TISDALE WEIR REHABILITATION AND FISH PASSAGE PROJECT

Final Environmental Impact Report

Prepared for
California Department of Water Resources

August 2021

Figure 15
TUFLOW Model – Change in Average Depth by Parcel (Wet Days)
Tisdale and Sutter Bypass (Below Normal WYs), Project Conditions

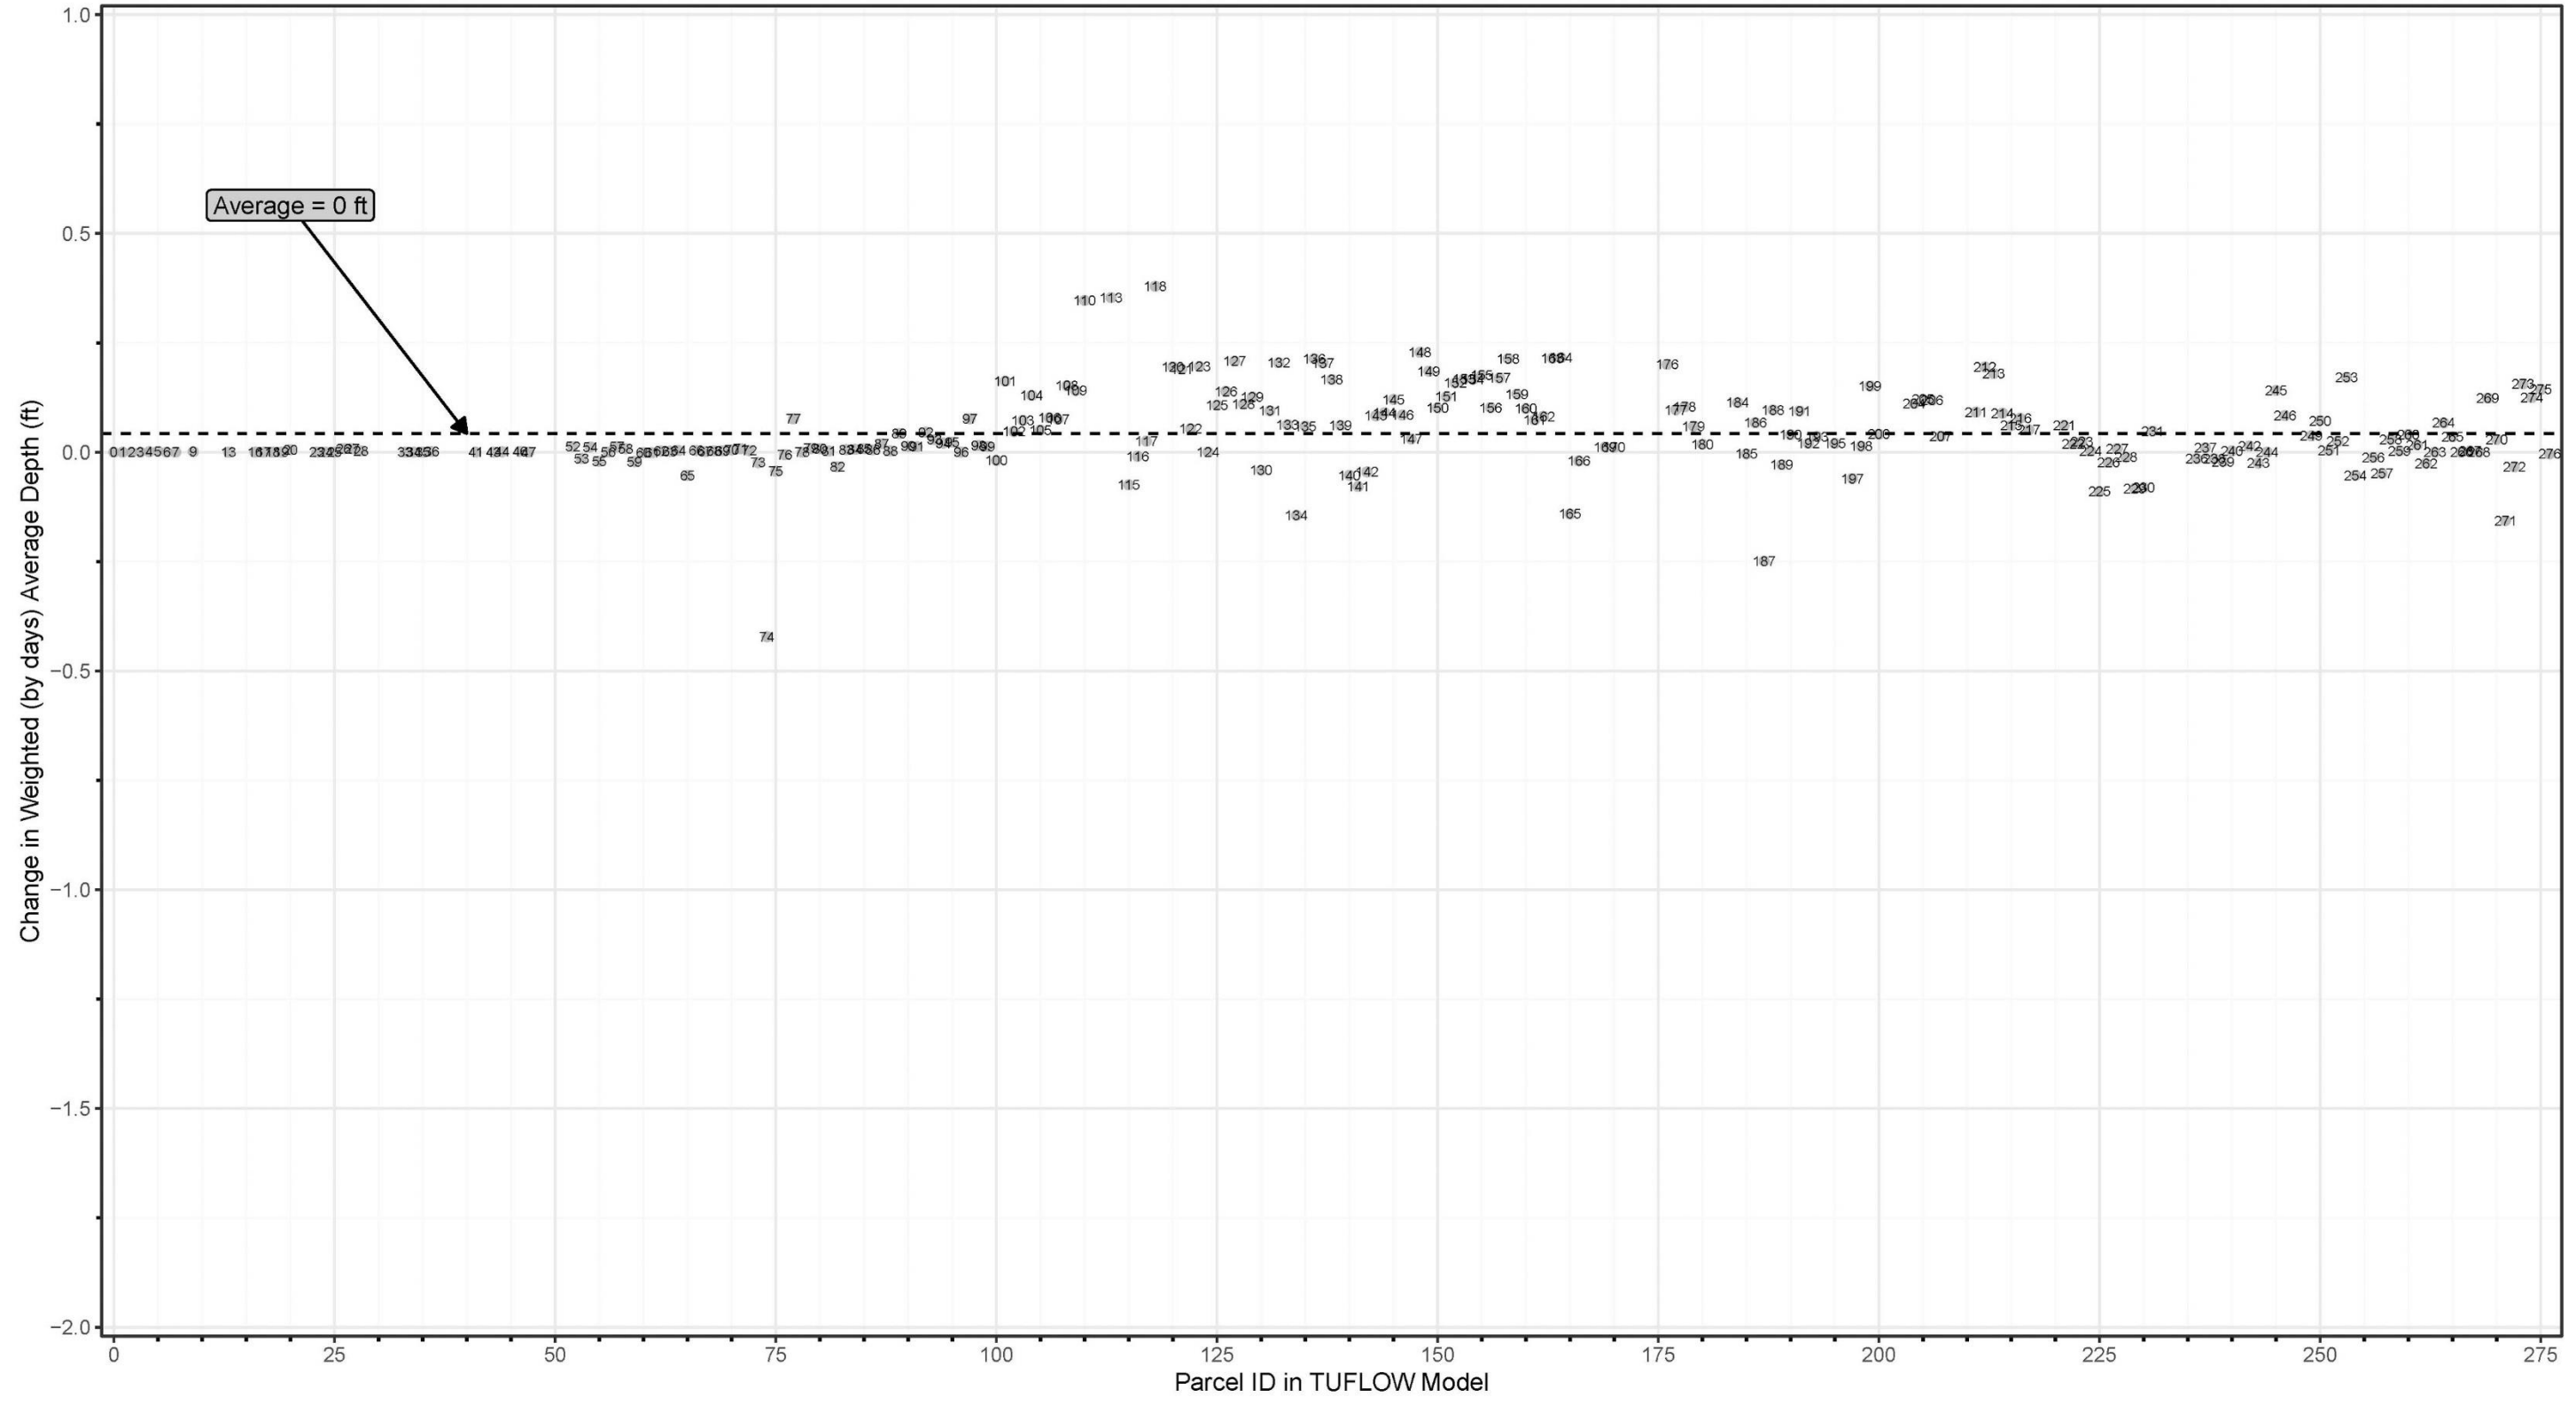
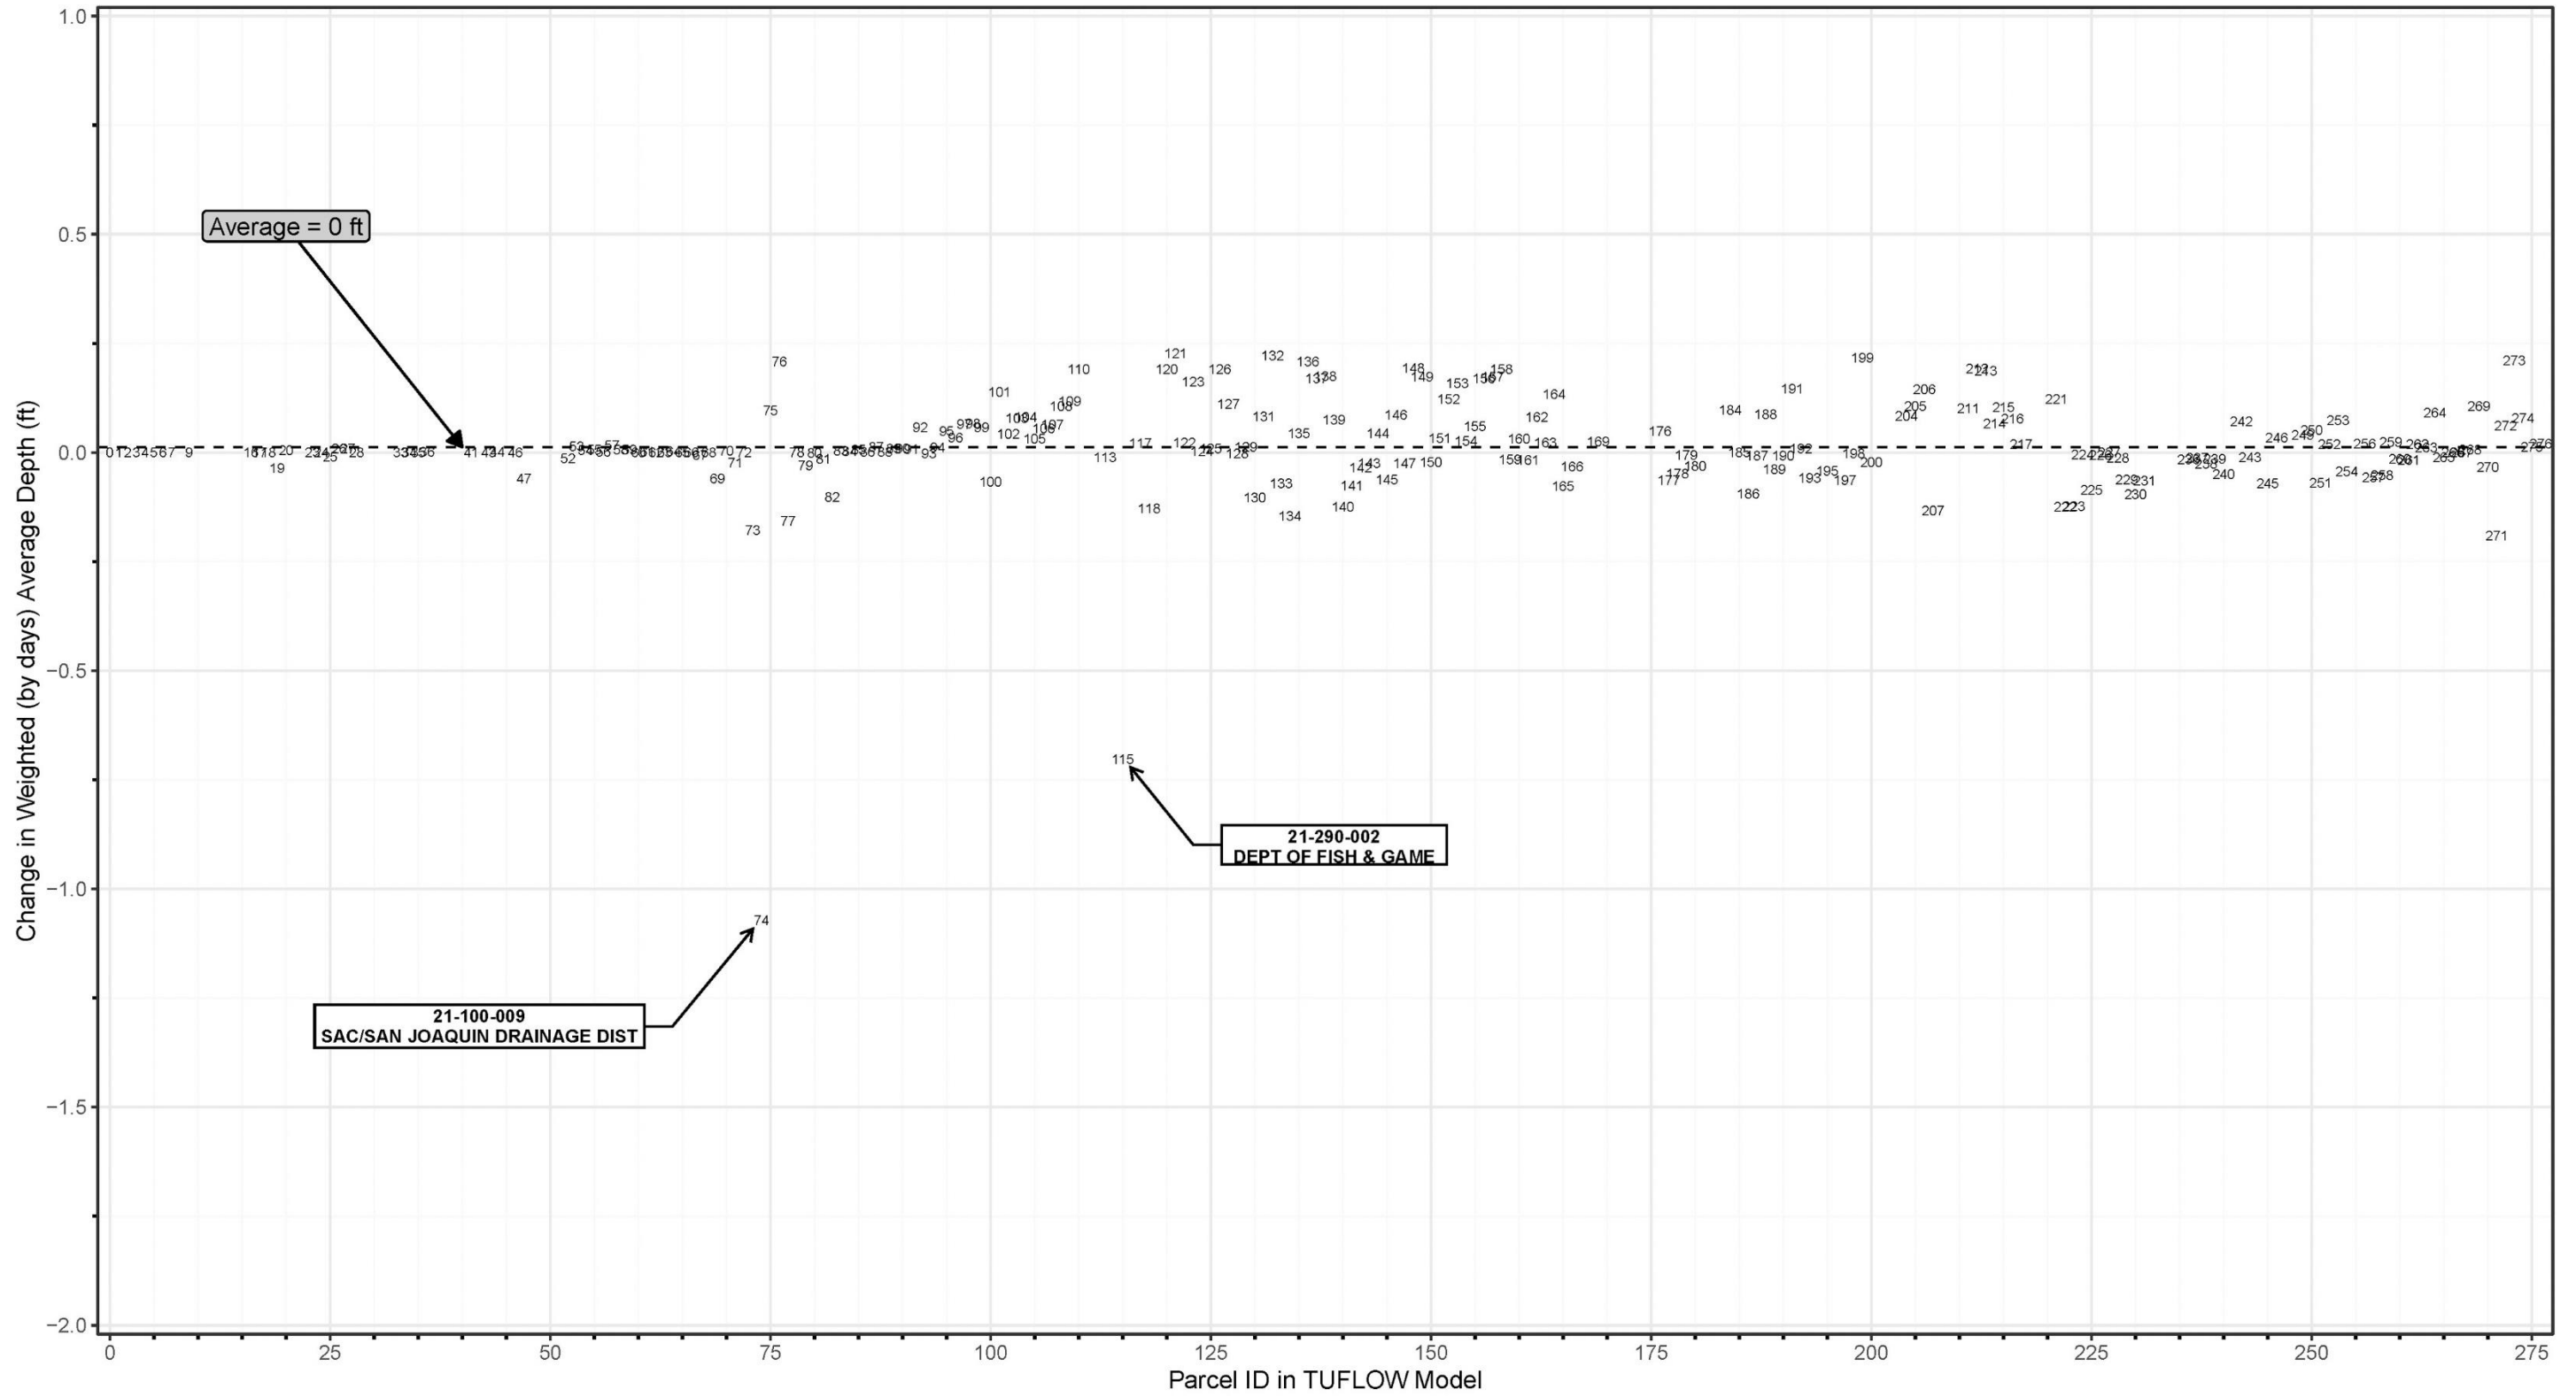
Figures 13 through 24 in Attachment E of this FEIR present the average changes in water depth, by water year type, for each parcel in the Sutter Bypass and, as shown, the predicted changes in water depth are very minor. As evident in Figures 13 through 24, the predicted increases in depth for wet days and dry days that are greater than approximately 0.5 feet are for parcels that belong to the Sacramento/San Joaquin Drainage District or the California Department of Fish and Wildlife (CDFW). In addition, Attachment F of this FEIR provides the change in the number of wet days for the waterfowl season for all water years and parcels in the Sutter Bypass.
